Change Order 03
Exterior Trench Drains on 1st Ave

Subcontract Change Order

Project: 201602. The Cora Apartments (19 W Harrison)
19 W Harrison
Seattle, WA 98109

Re: Cora Apartments – Change Order Request #7 Exterior Trench Drains on 1st Ave

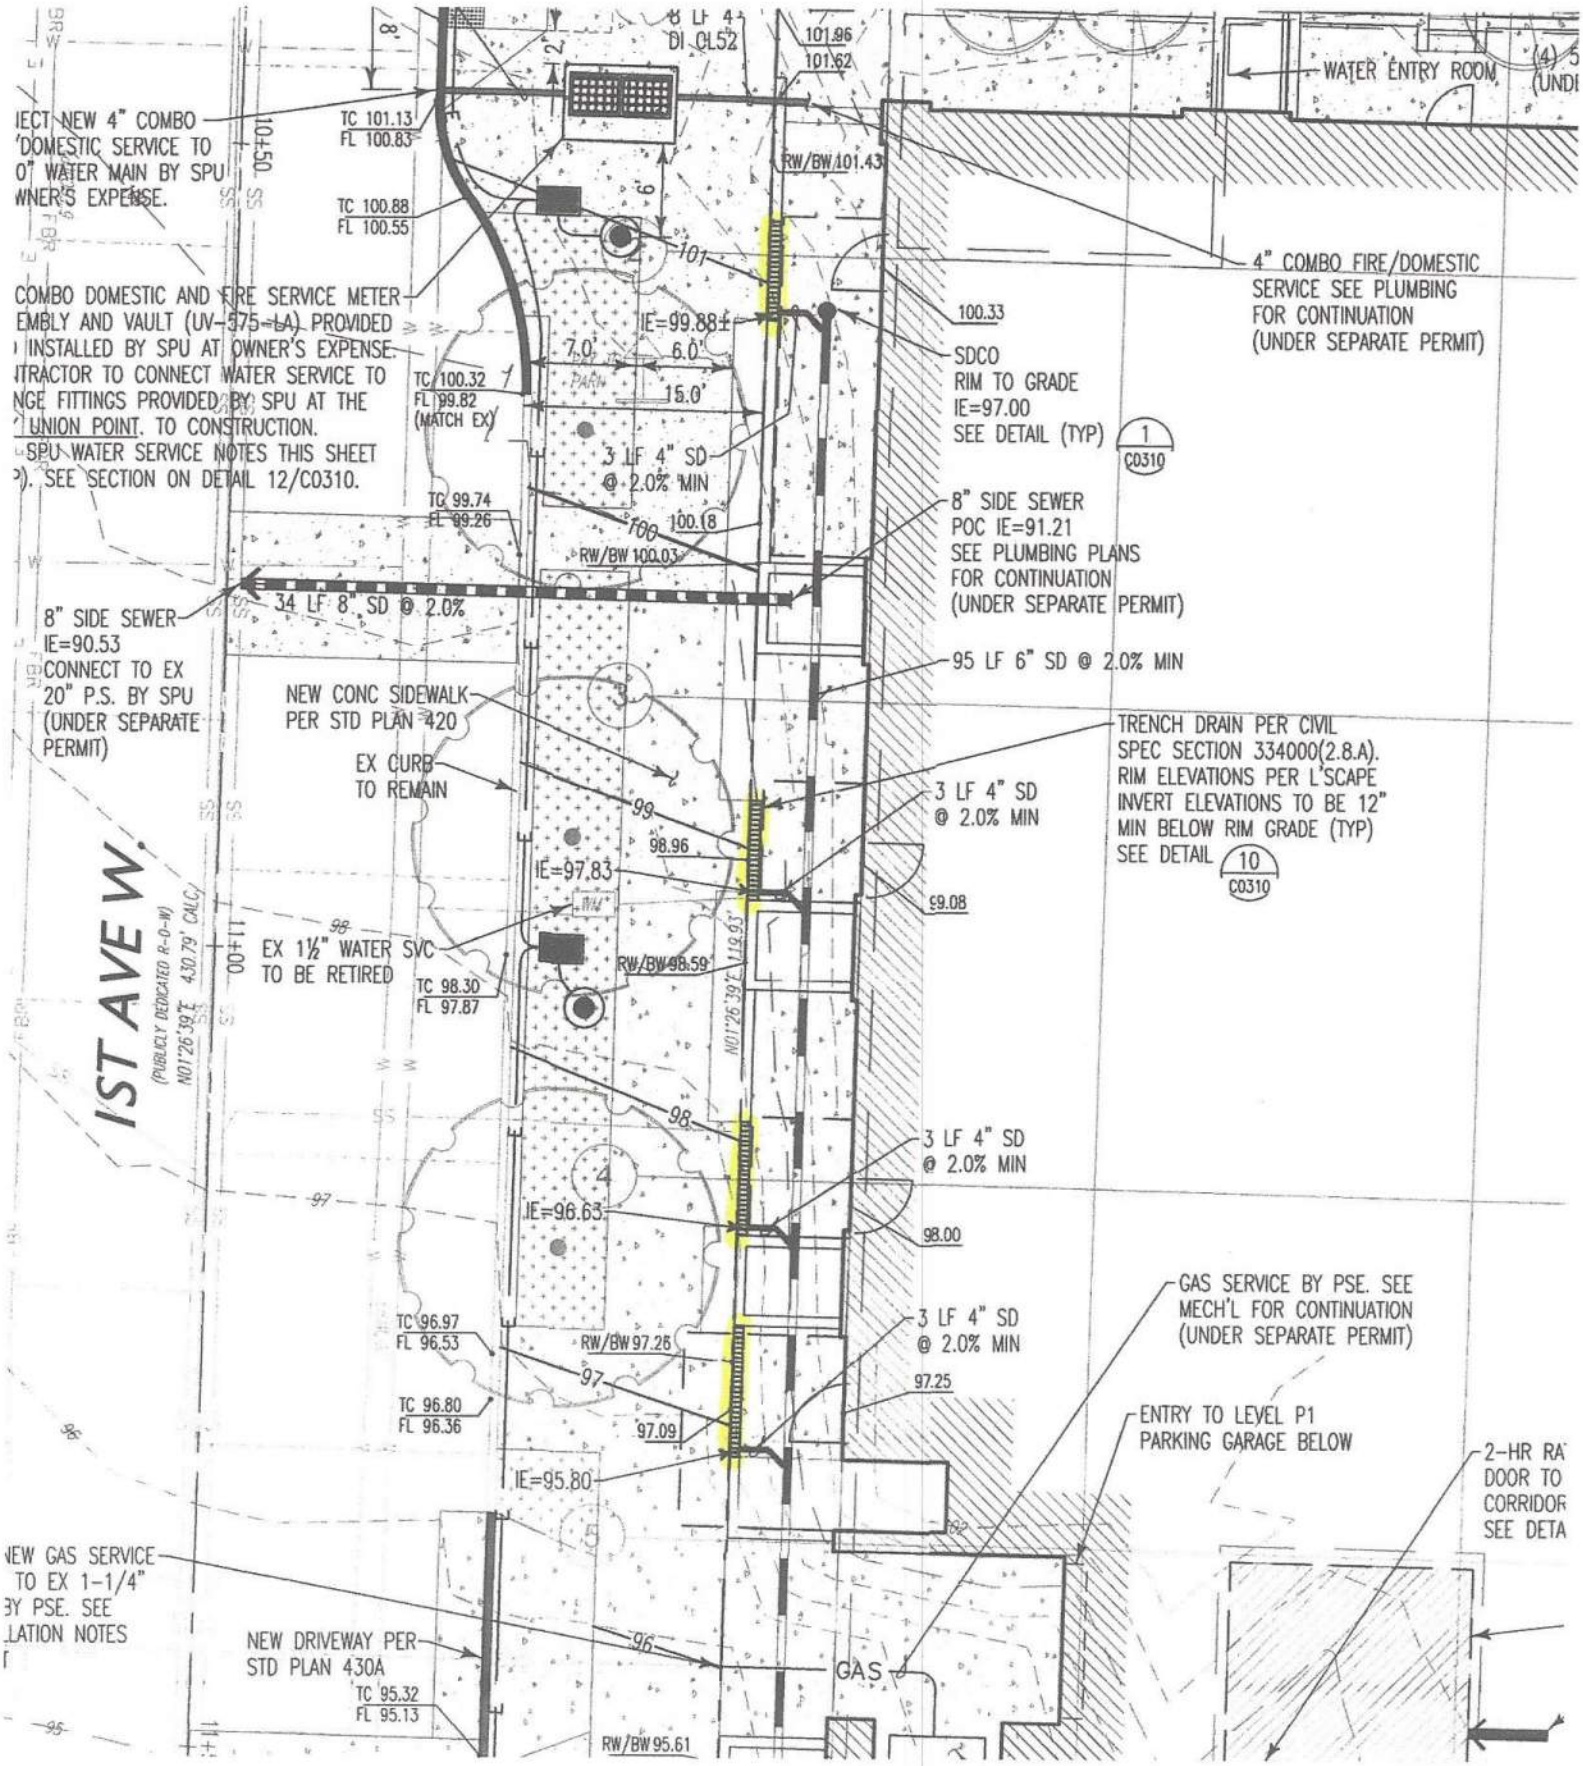
One Way Plumbing, LLC - Added Exterior Trench Drains on 1st Ave.
Reference COR 07 - Install (4) trench drains along 1st Ave. W, as highlighted attached, NDS DS-090N trench drains and DS-226 stainless steel grates per attached submittal. All mainline storm piping is by others. Trenching/excavation is excluded. Fine grading included.
Total Added: $7,881.00 ($6,853.00 + 15% OH&P)

Total cost to install the 4ea trench drains along 1st Avenue West, as highlighted attached, is $$6,853 + 15% OH&P = $7,881. We plan to use NDS DS-090N trench drains and DS-226 stainless steel grates per attached submittal. All mainline storm piping is by others. We will hook up to storm via tee left by others. Trenching/excavation is excluded. We will fine grade only.
